Maughanaclea Wind Farm Observation

Case reference: PAX04.324165

Description: 10-year planning permission for Maughanaclea Wind Farm consisting of 14 no. wind turbines, a 110kV substation and 110kV underground cabling connection and associated works by Maughanaclea Ltd

Images of T07, T08 and T09 viewed facing westward

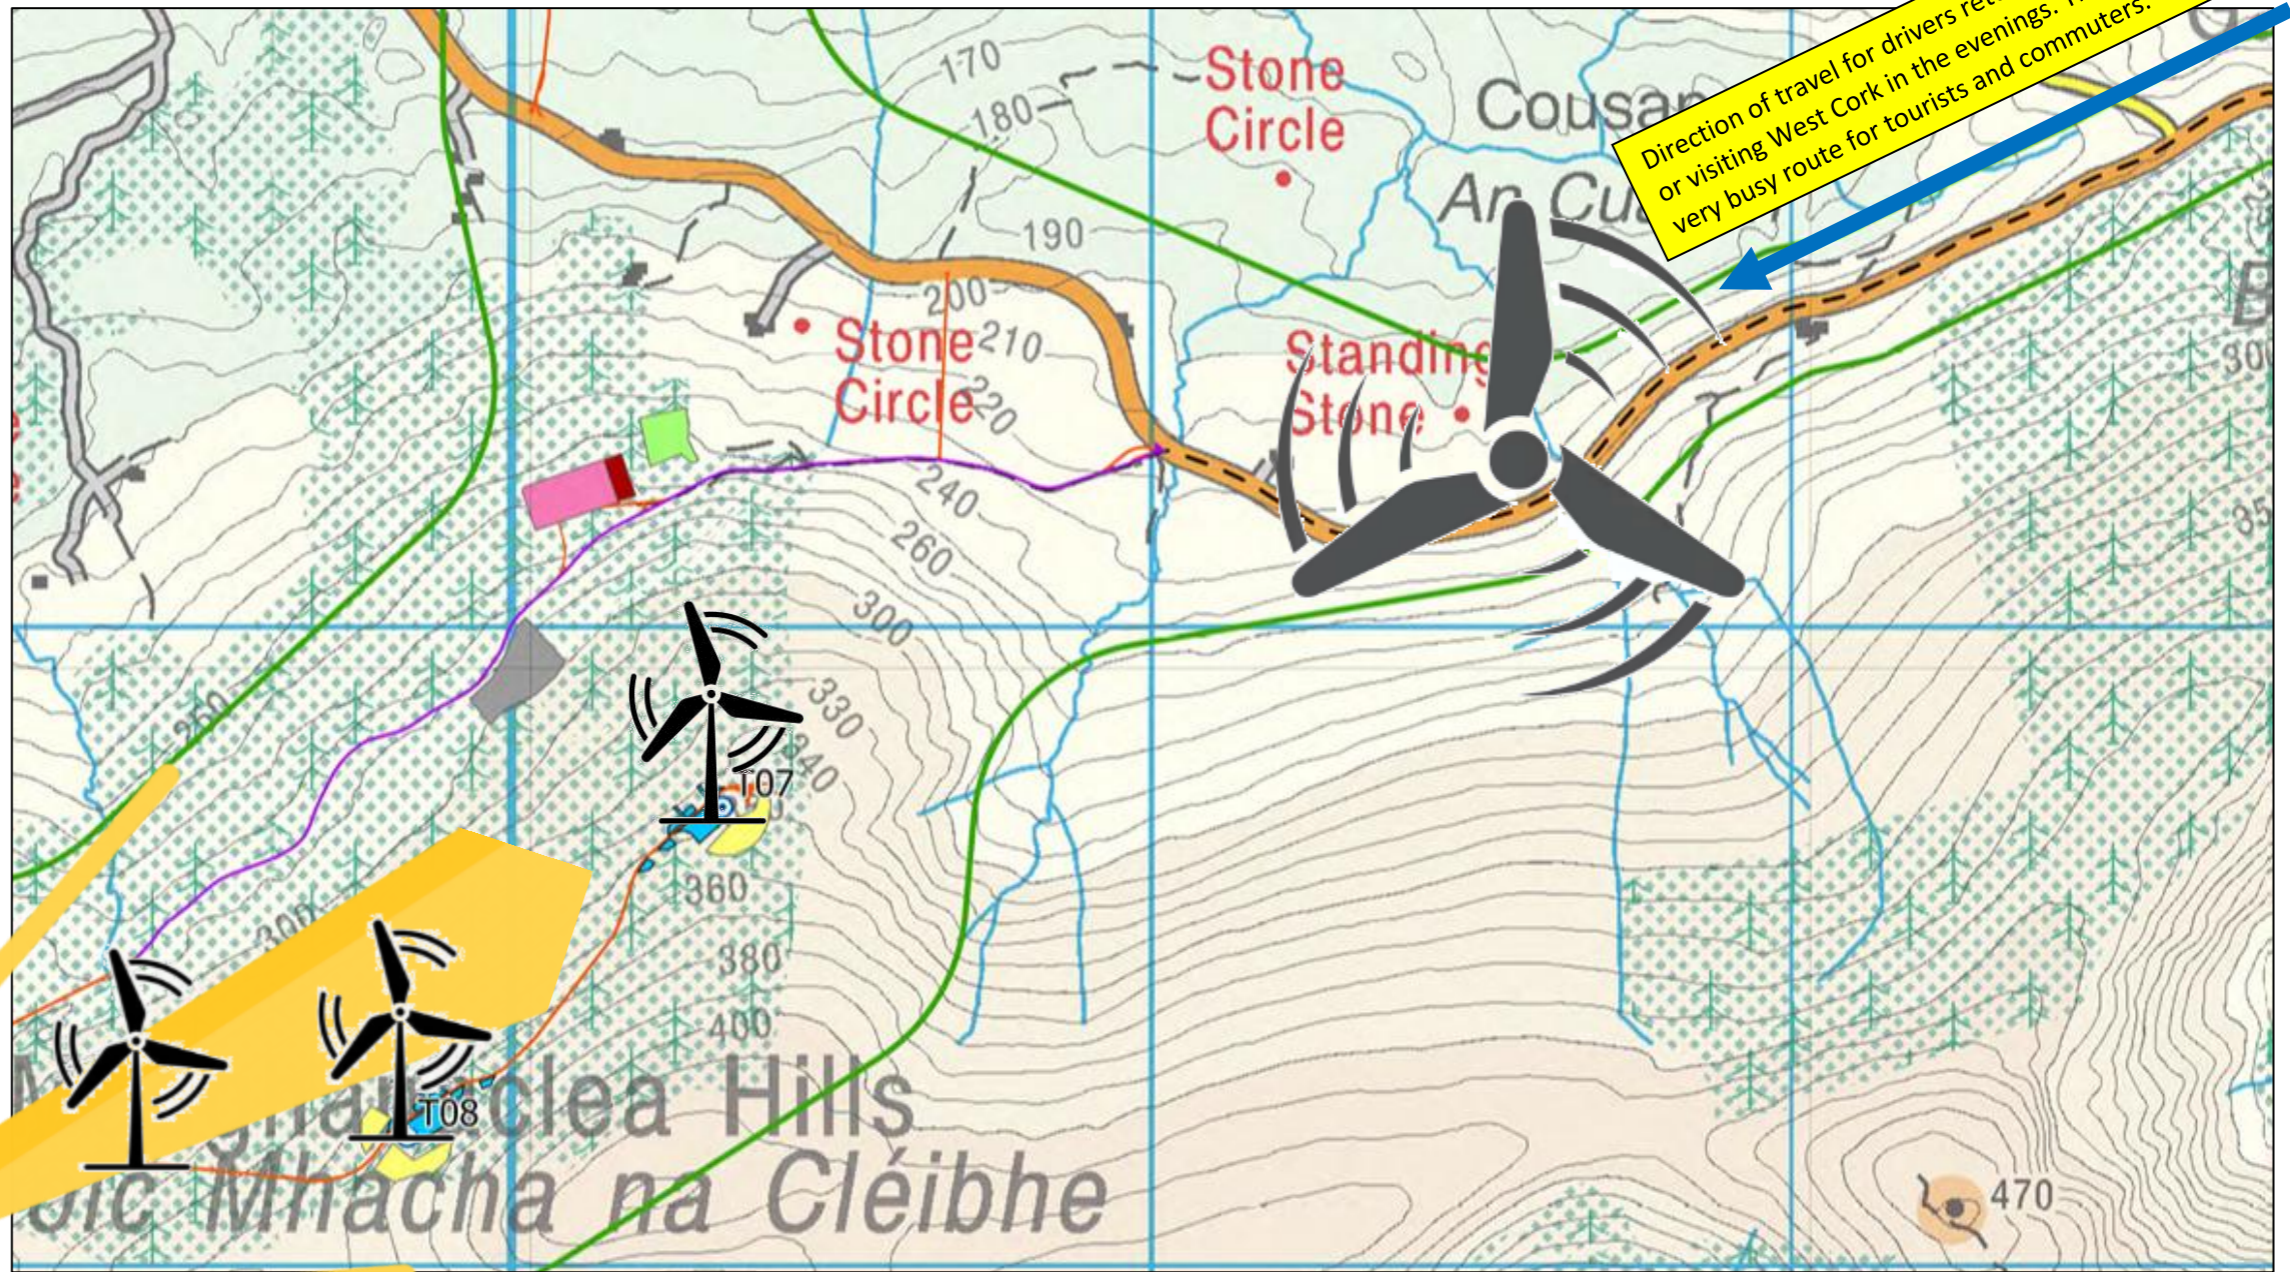
In light of the alignment of turbines T07, T08 and T09 relative to the R585, can the Board demonstrate how it is satisfied that the proposed development will not give rise to a hazard or distraction risk for road users, particularly during winter evenings when westbound drivers are exposed to low sun conditions?

In these circumstances, where the turbines are positioned directly between drivers and the descending sun, resulting in the potential for rapid light–dark strobing across the carriageway due to rotating blades, can it be demonstrated that the combined effects of sun glare, intermittent shadow flicker and vehicle speed have been adequately assessed?

It is noted that no specific assessment appears to have been undertaken in respect of this stretch of the R584, notwithstanding its alignment with the affected turbines and the predictable occurrence of low-angle winter sun conditions. In light of this omission, can the applicant be required to undertake a dedicated road safety and visual distraction assessment, including seasonal modelling of shadow flicker across this section of roadway and an evaluation of driver response under worst-case conditions?
